TENTATIVE SUBDIVISION PLAN

SUBJECT: **PUBLIC WORKS RECOMMENDATIONS**
SUB-ADJ19-02 (18-125034-LD)
575 SALEM HEIGHTS AVENUE S
34-LOT SUBDIVISION

Re: Wren Heights (Salem Heights) Subdivision - #18-125034-LD

TREE CONSERVATION PLAN

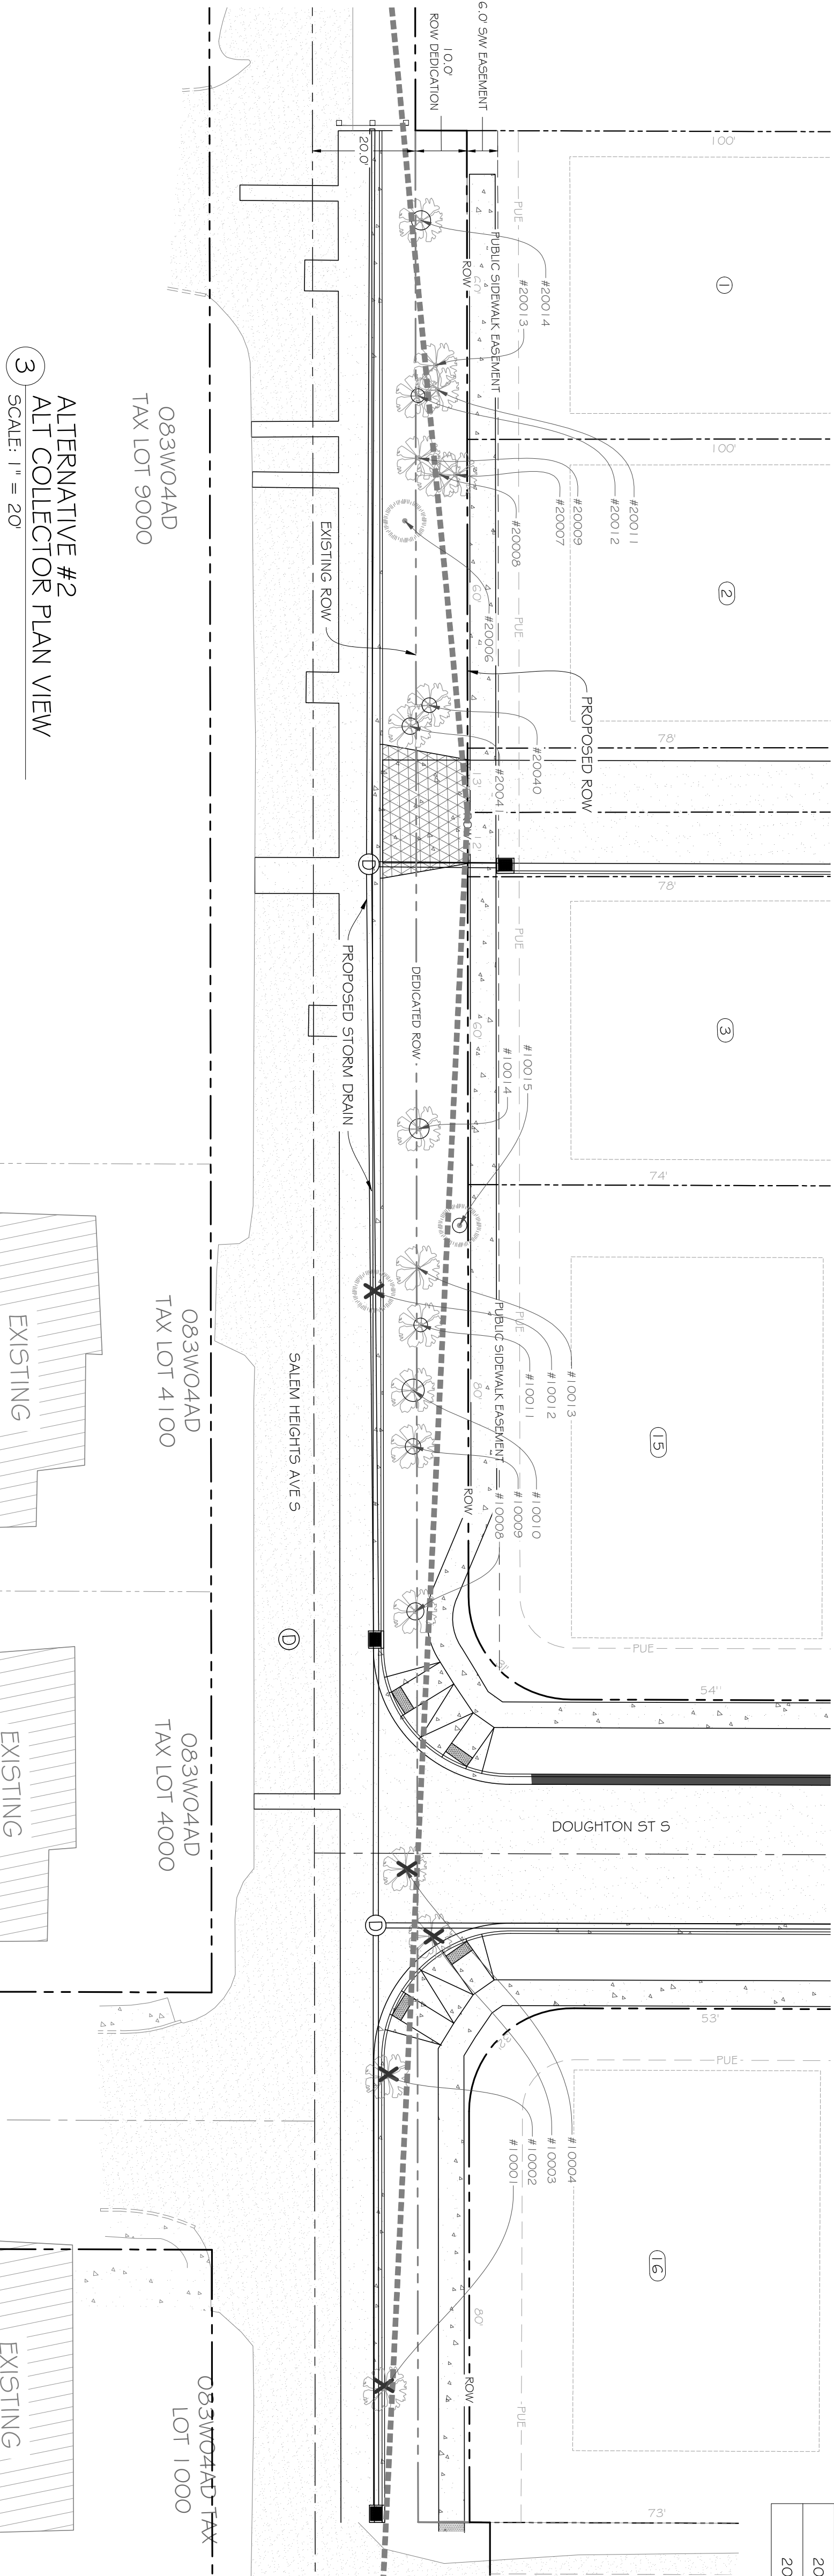
2. Prior to issuance of Public Construction permits, obtain tree removal permits for trees located within the right-of-way along the frontage of Salem Heights Avenue S. In accordance with the plan submitted on May 7, 2019 and titled Trees Within Right-of-Way Conservation Plan (C-1.17), trees labeled as 10001 – 10004, and 10012 are tentatively approved for removal. Any additional removal of street trees requires

3. Prior to issuance of Public Construction permits, a tree preservation and protection plan pursuant to SRC Chapter 86 and Salem Administrative Rule 109-500, and signed by a certified arborist, shall be submitted to the City for review and approval. In accordance with the plan submitted on May 7, 2019 and titled Trees Within Right-of-Way Conservation Plan (C-1.17), trees labeled as 10008 - 10011, 10013 – 10015, 20006- 20009, 20011- 20014, 20040, and 20041 are slated for preservation.

future street trees. In accordance with the plan submitted on May 7, 2019 and titled Trees Within Right-of-Way Conservation Plan (C-1.17), trees labeled as 10001 – 10004, and 10012 are tentatively approved for removal. The applicant shall obtain tree removal permits pursuant to SRC Chapter 86 prior to issuance of Public Construction permits for the street improvement of Salem Heights Avenue S. Any additional removal of street trees requires approval pursuant to SRC 86.090. For all remaining trees (10008 - 10011, 10013 – 10015, 20006- 20009, 20011- 20014, 20040, and 20041), a tree preservation and protection plan pursuant to SRC Chapter 86 and Salem Administrative Rule 109-500, and signed by a certified arborist, shall be submitted to the City for review and approval prior to the issuance of Public Construction permits.
